PRODUCT CHANGE NOTIFICATION

Select Bourns® Transient Voltage Suppressor (TVS) Diodes

Addition of Manufacturing Site

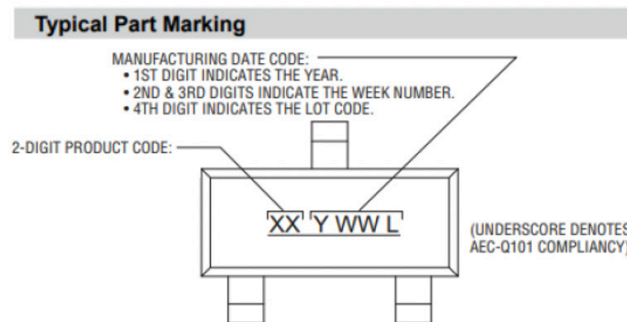
The Si fabrication and the assembly process will not change at this new additional assembly and test manufacturing site. The part marking will be used to identify units produced at the new additional assembly and test manufacturing site. The lot code (L) of the new site will use alphabetic characters while the current site will continue to use numbers.

The form of the part numbers made at the new additional manufacturing plant will change because of a small change in the part marking for traceability purposes. The fit, function, quality, reliability and performance of the overvoltage protectors produced at the new manufacturing plant will be the same as those of the existing plant. The production lead times of these overvoltage protectors should improve gradually as our capacity is expanded. The country of origin will remain the same.
